*TOLEDO CITY  
PLAN COMMISSION  
REPORT*

*March 10, 2016*

**TOLEDO-LUCAS COUNTY PLAN COMMISSIONS  
APPLICATION DEADLINE, AGENDA, STAFF REPORT AND HEARING  
SCHEDULE - 2016**

# SITE PLAN

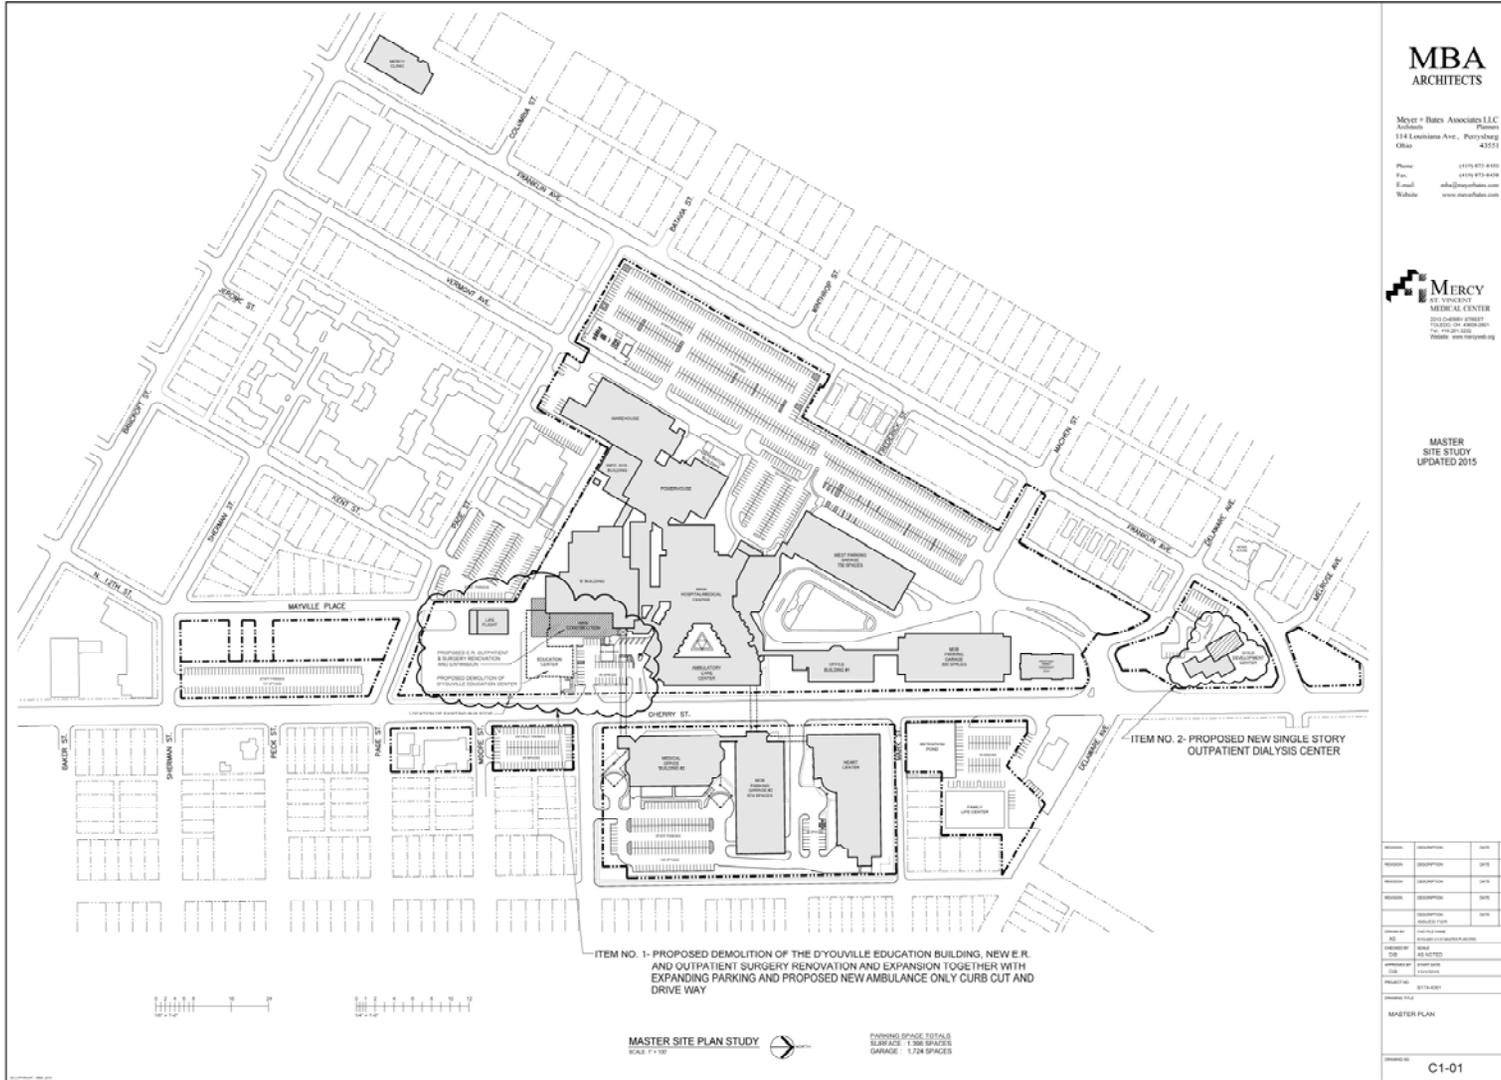
5. Detailed plans for the water services shall be submitted to the Division of Engineering Services for review and approval. Plan design and submittal shall comply with the current version of the City of Toledo DPU Infrastructure Design and Construction Requirements.
6. Detailed plans for the storm-water services, including a detailed site-grading plan, Storm Water Pollution Prevention Plan (SWP3), and storm-water calculations, shall be submitted to the Division of Engineering Services for review and approval.
7. Plan design and submittal shall comply with the current version of City of Toledo DPU Infrastructure Design and Construction Requirements available at <http://toledo.oh.gov/services/public-utilities/div-engineering-services/plan-review-process/>.

8. Within the City's Design and Construction Requirements, as listed above, the City does have storm-water detention requirements within a combined-sewer area for earth-disturbing activity greater than 2,500 square feet. (Overall common plan of development is considered.) The City recommends that this requirement is closely observed during the planning stages of the project, as space may be needed to accommodate the detention.
9. Designs incorporating low impact development solutions, such as grassy swales and bio-retention areas in lieu of curb, storm sewers, and underground detention, are encouraged and may be eligible for a percent reduction in the property's storm-water utility fee through the Storm Water Credit Program.
10. A pre-submittal meeting is not required; however, one may be requested. Contact Information is as follows:

14. Any existing sewers under proposed buildings shall be relocated or abandoned. Developer shall verify any sewers to be abandoned are no longer in service.

15. The master plan must include the modifications to the parking area affected by this expansion project. The revised Master Plan shall be submitted for review and approval by the Division of Transportation.

# SITE PLAN

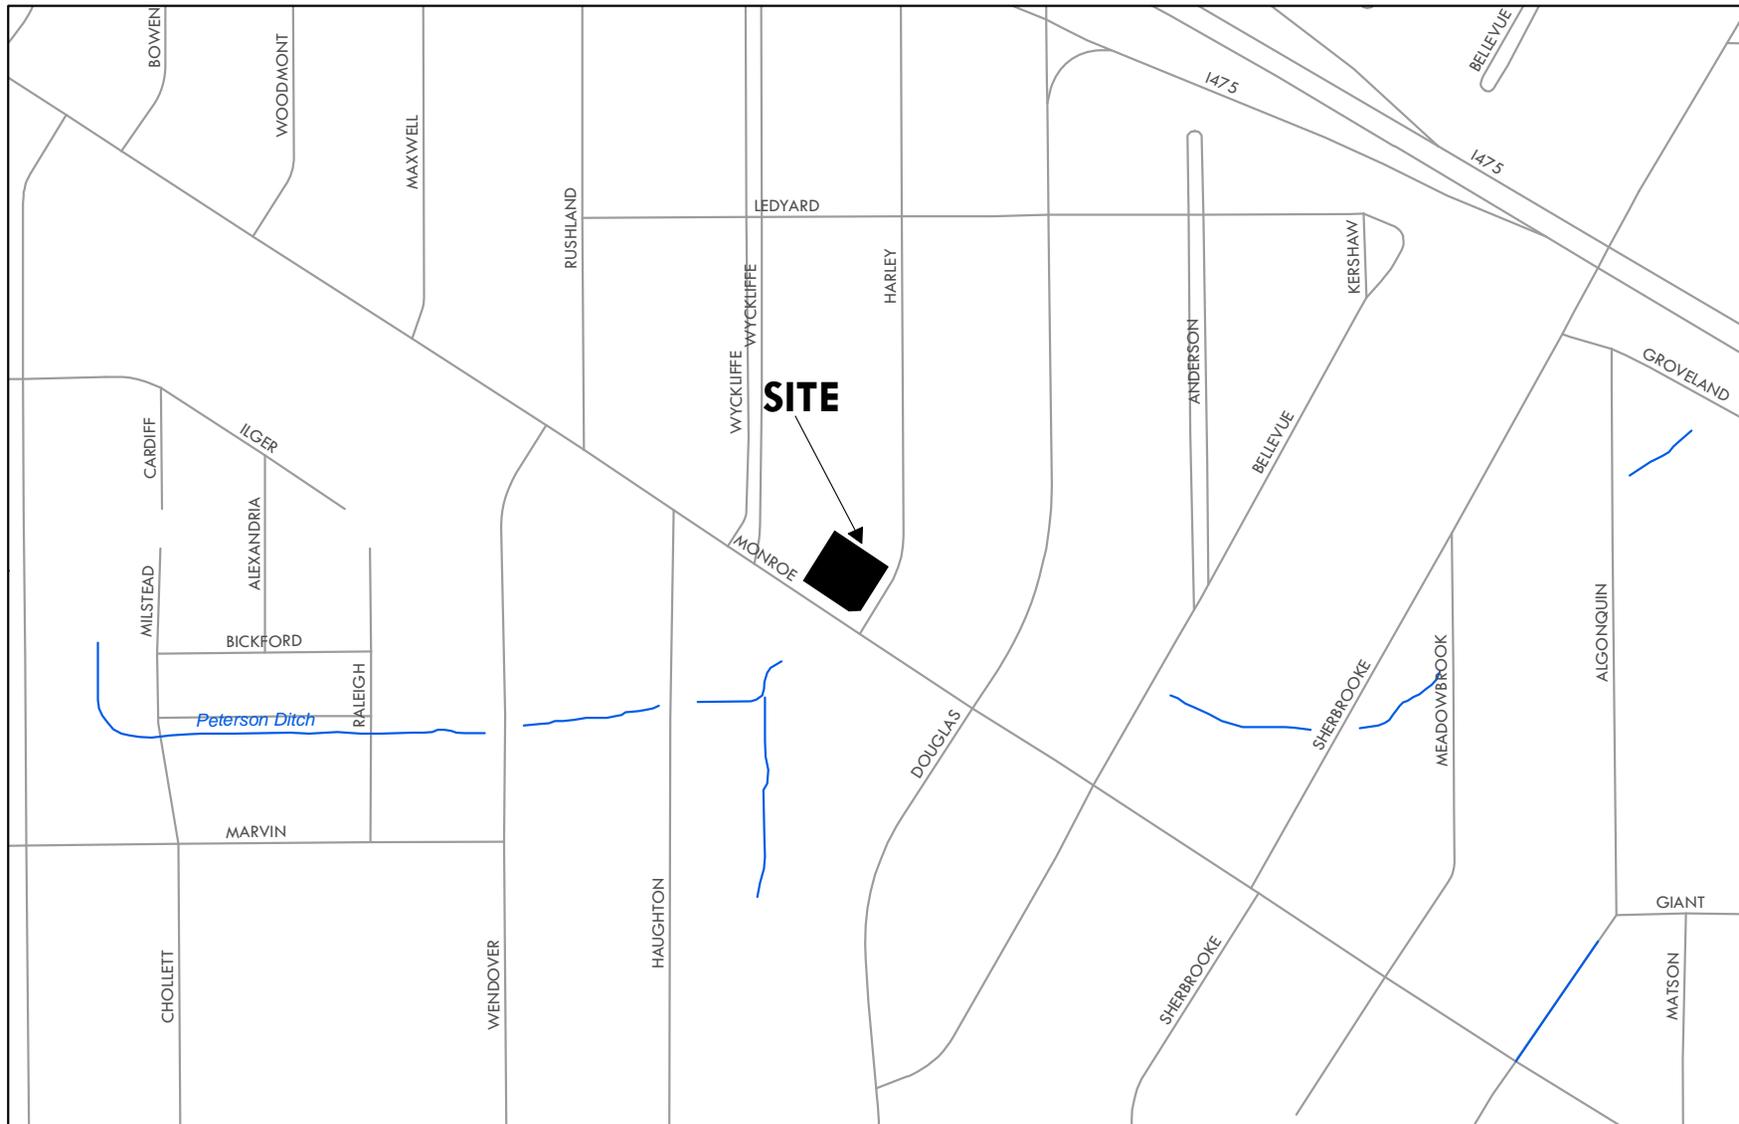
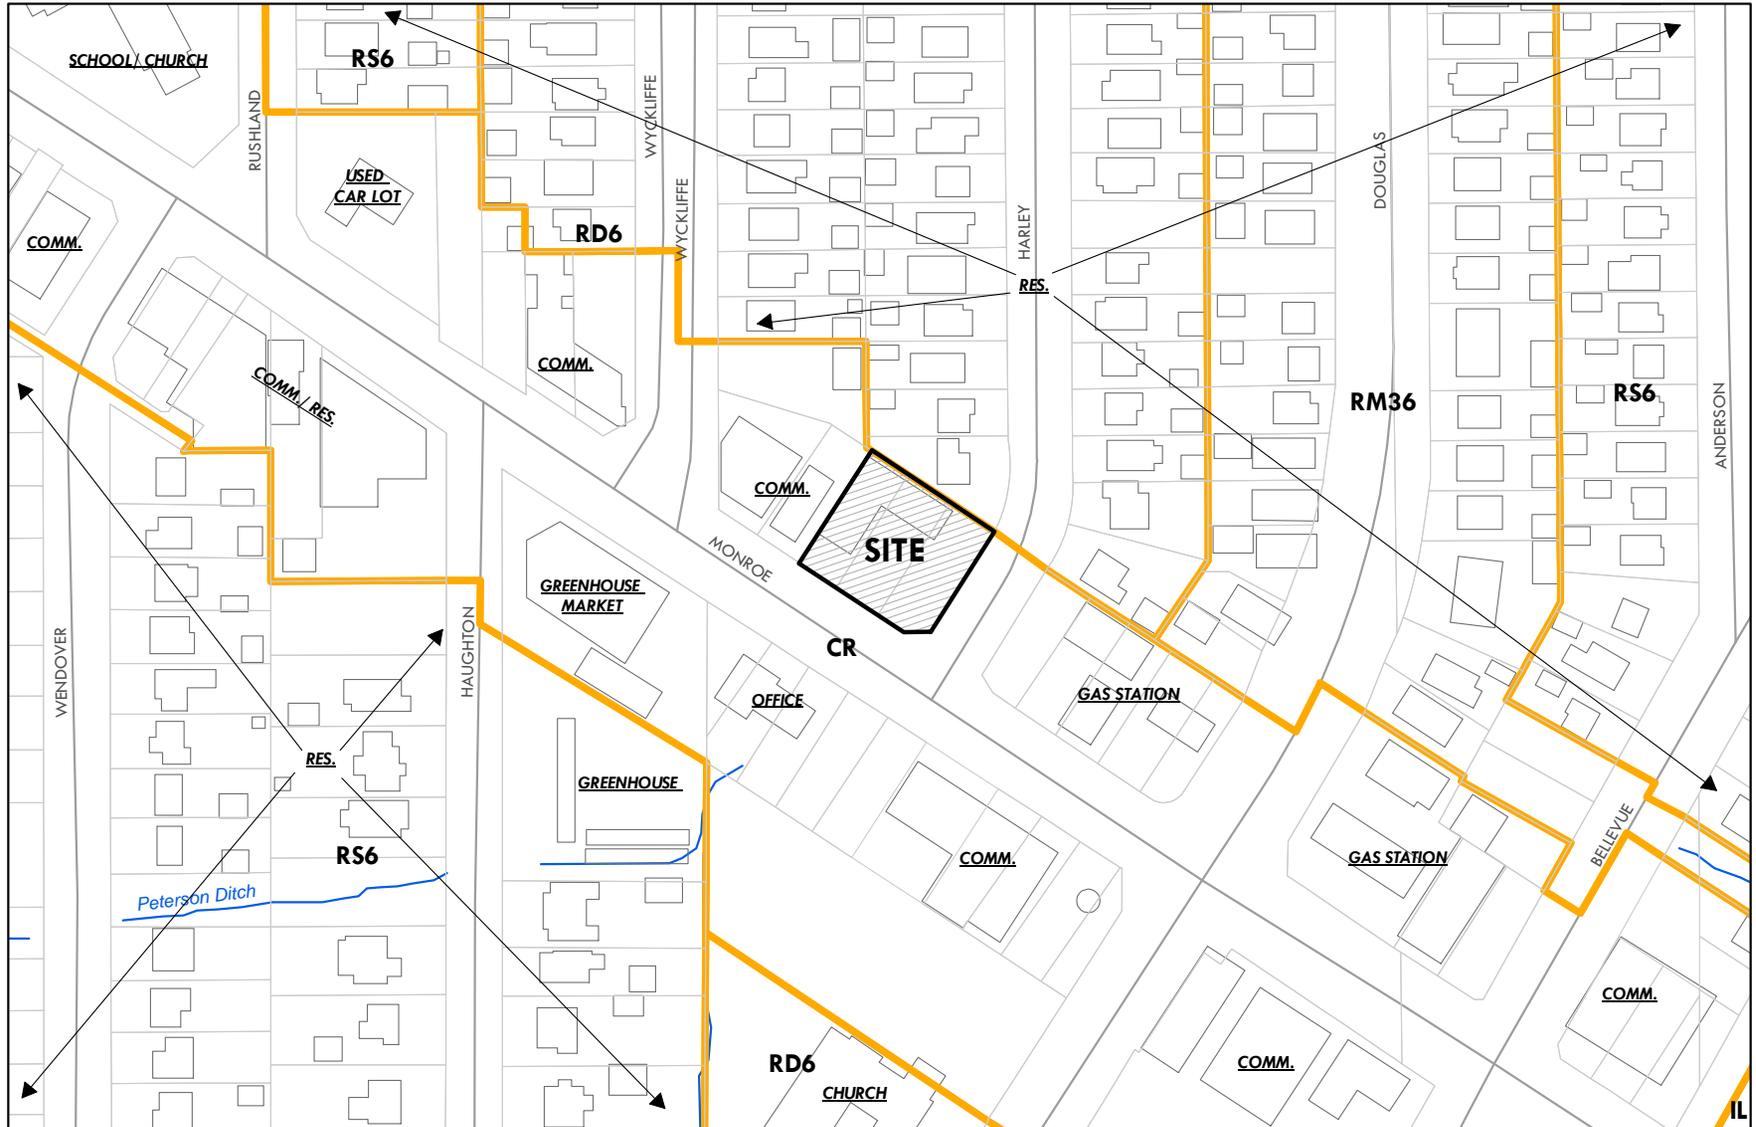
Plan Commission Staff sent a noncompliance letters to the applicant on January 16, 2015 and January 28, 2016 and Code Enforcement has indicated that they have contacted the applicant concerning the conditions of the site and overall compliance with Ord. 70-14. The applicant met with Staff on February 24, 2016 and indicated that he is working towards compliance. Staff feels the applicant can make significant progress and achieve possible full compliance within ninety (90) days.

The staff recommends that the Toledo City Plan Commission recommend a ninety (90) day compliance period to allow the applicant to bring the site into compliance with Ord. 70-14, a Special Use Permit for a Used Auto Sales Facility, located at 4154, 4158 & 4160 Monroe Street, to the Toledo City Council.
